The following Report on Water Supply, Kowloon, by LAWRENCE GIBBS, A.M.I.C.E., which was laid before the Legislative Council this day, is published.

Re Hongkong—Water Supply of Kowloon.

REPORT ON WATER SUPPLY OF KOWLOON.

KOWLOON WATER SUPPLY.

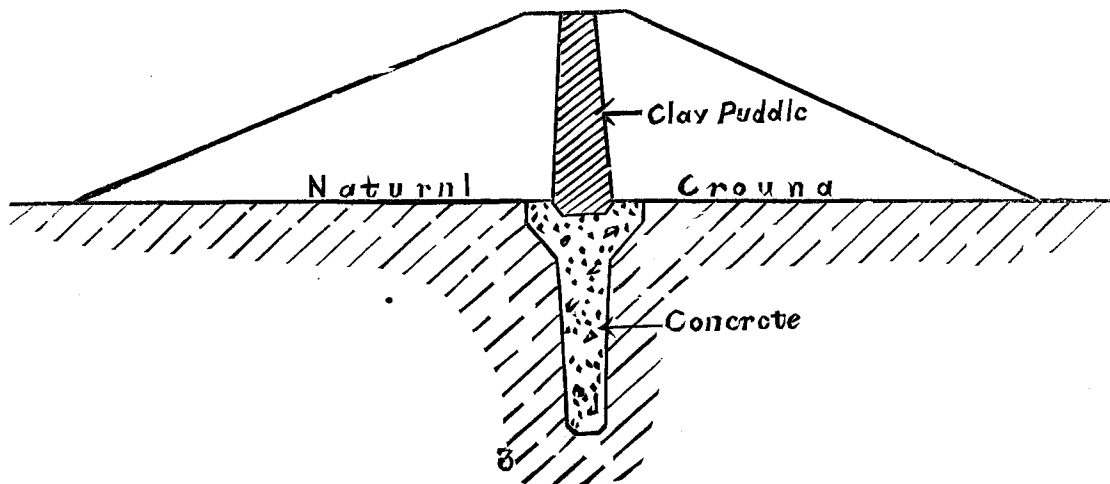
4.—It is proposed to make an earthen dam with a puddle wall in the centre in the ordinary manner, at sources Nos. 1 and 2, on account of apparent scarcity of good building stone. I must, however, record my opinion that a masonry or concrete dam, like that at Tytam, will be far preferable, even if it cost somewhat more. With a masonry dam, a leakage merely amounts to a loss of water. With an earthen dam, it may result in destruction. I therefore recommend that careful examination be made for building stone, before earth is decided upon as a material. I have never visited the mainland, beyond the former frontier; but I presume that the geological formation is similar to that of Hongkong, where solid masses of granite are found imbedded in decomposed granite; but not visible at the surface. If I remember rightly, in the Tytam Valley, in its original condition, very little rock appeared at the surface; yet plenty of stone was obtained. It must be clearly understood that, with care, a thoroughly efficient and safe reservoir can be constructed. I merely assert that, if stone can be obtained, masonry or concrete is a preferable material.

5.—I am of opinion that, unless the most excellent puddle clay is readily obtainable, a concrete stop wall is preferable to a puddle wall. At any rate it is good practice to fill in the puddle trench below ground with concrete, using puddle only in the bank, thus:—

4. I entirely concur with Mr. CHADWICK as to the advantages a masonry or concrete dam possesses over an earthen one, and after a further careful examination of the ground, have found an excellent site for a masonry dam 600 feet lower down the stream than the site proposed by Mr. GIBBS for the earthen dam and 30 feet below it in level. At the site I now recommend adopting, two other considerable streams have joined that intercepted by Mr. GIBBS' dam, the combined waters passing through a narrow cleft over solid hard rock. It is evident that sufficient good stone for the dam can be obtained in the vicinity. The geological formation is similar to Hongkong and granite boulders in decomposed granite are plentiful.
